Service Bulletin No: 21-012

Modification No: EC-14-0359

AIR CONDITIONING - COOLING**INSTALL A COVER ASSEMBLY TO THE COMPRESSOR TO PROTECT TO THE ENGINE OIL HOSE****1. Planning Information****A. Effectivity**

Installation of the Cover Assy
Figure 1

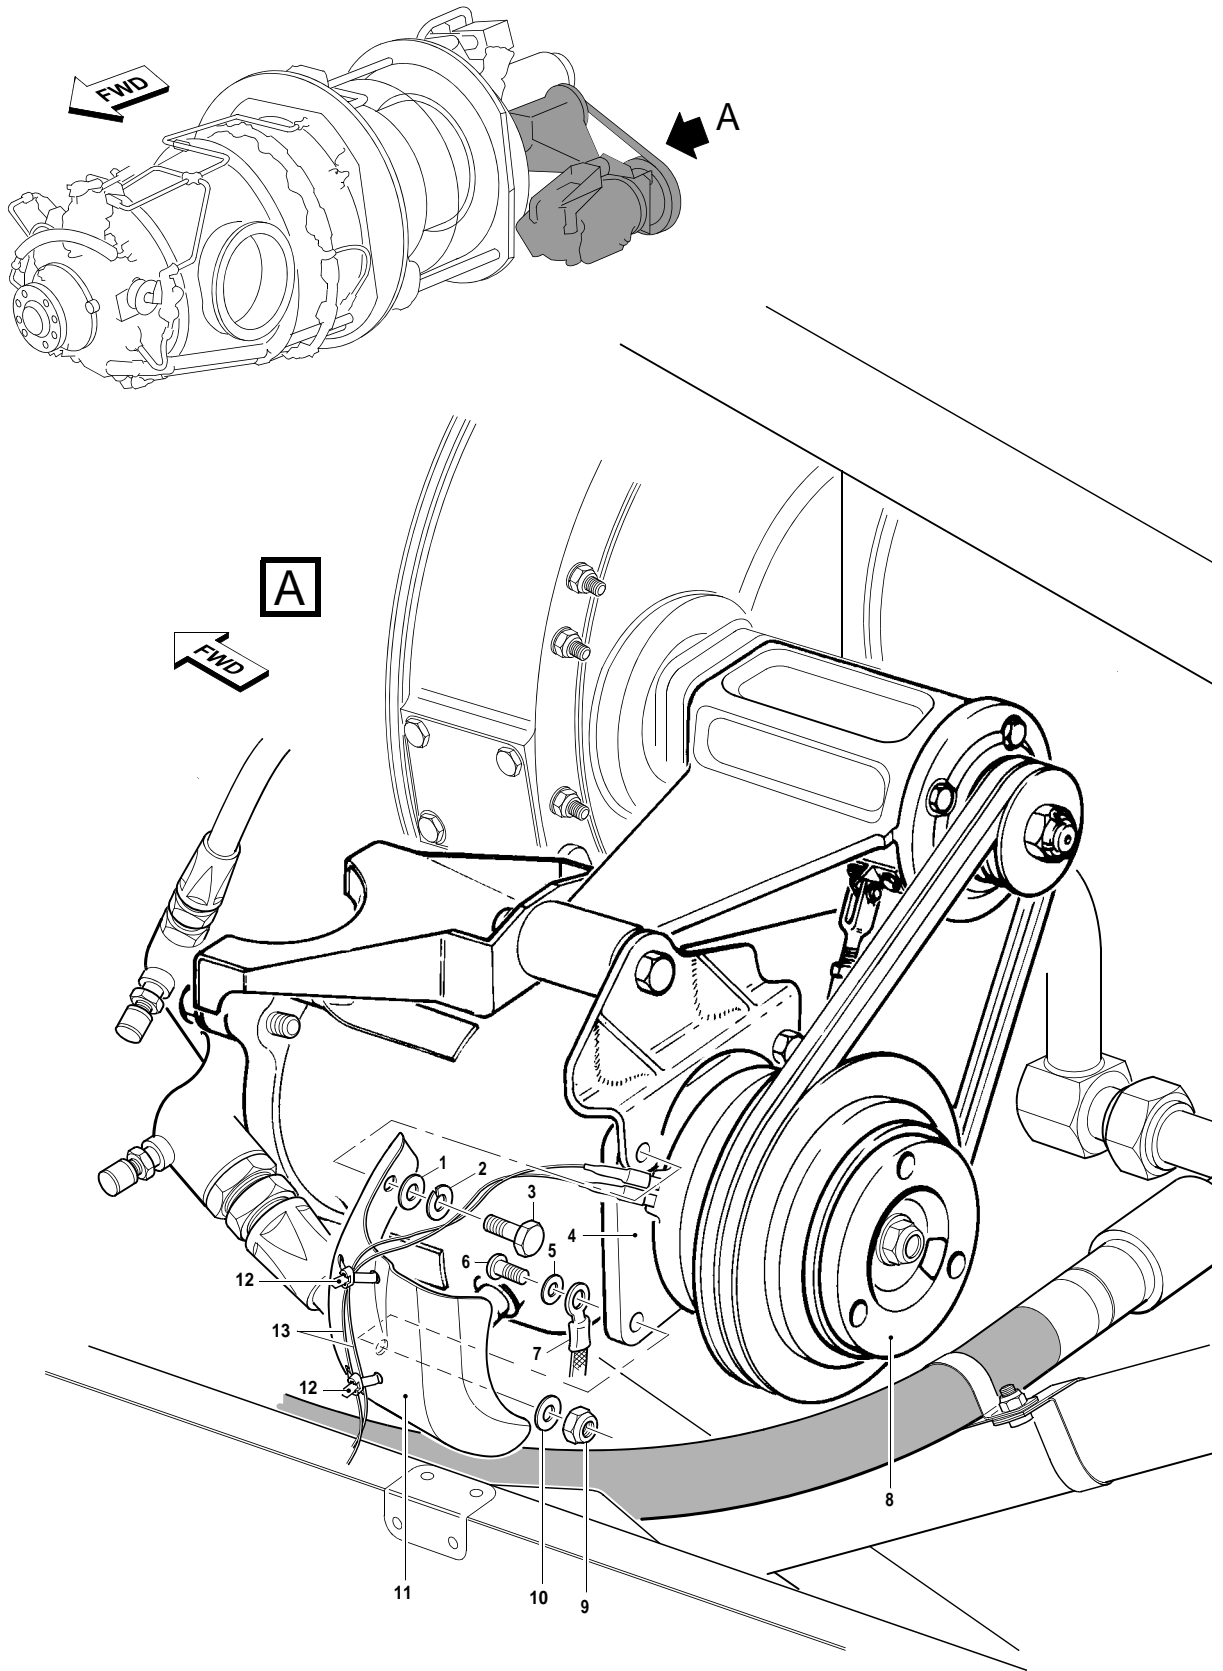
On PC-7 aircraft that are pre Service Bulletin 21-006, the oil cooler inlet-hose is routed close to the air conditioning compressor clutch plate. If a spring on the compressor clutch plate shears, the oil hose can become damaged and the engine oil can spill into the engine bay.

Install a cover assy which will be mounted on the attachment points of the compressor. This will provide a barrier between the compressor clutch plate and the oil hose. The shield can be mounted on the compressor support bracket with the current bolts.

NOTE: On Pre Service Bulletin installations, the ground lead (7) is installed on the aft face of the plate (4) (opposite to that shown in Figure 1). The washer (5) is not installed.

NOTE: On Post Service Bulletin installations, the ground lead (7) is installed on the forward face of the plate (4) (as shown in Figure 1).

- (1) Remove, and keep, the bolt (3), the spring washer (2) and, if installed, the washer (1).
- (2) Remove, and keep, the nut (9), the washer (10), the ground lead (7) and the screw (6).

- (3) Prepare the plate (4) for the new position of the ground lead (7):
 - (a) Make a circular mark on the forward face of the plate around the lower attachment hole, approximately 10 mm from the edge of the hole.

- (d) Apply layers of the Alodine 1132 (Material No. P07-021) on the bare metal area and allow to dry.
- (4) Put the cable ties (12) through the holes in the cover assy (11) (P/N 521.50.07.022).

- (5) Put the cover assy (11) (P/N 521.50.07.022) in position on the aft face of the plate (4) and around the pulleys (8).
- (6) Put the spring washer (2) and, if necessary, the new washer (1) (P/N 938.75.11.311) on the bolt (3).

- (7) Loosely install the bolt (3), complete with the spring washer (2) and the washer (1).
- (8) Put the ground lead (7) and the washer (5) (P/N 938.77.11.110) on the screw (6).

- (9) Install the screw (6), complete with the ground lead (7) and the washer (5) (P/N 938.77.11.110), the washer (10) and the nut (9).
- (10) Tighten the bolt (3).
- (11) Make sure there is no interference between the pulleys (8) and the new cover assy (11) (P/N 521.50.07.022).
- (12) Use the cable ties (12) to attach the cables (13) to the cover assy (11) (P/N 521.50.07.022).
- (13) Apply a layer of Dinitrol AV40 (Material No. P10-013) to completely cover:
 - The screw (6)
 - The washer (5) (P/N 938.77.11.110)
 - The ground lead (7)
 - The bare metal of the plate (4)
 - The washer (10)
 - The nut (9).
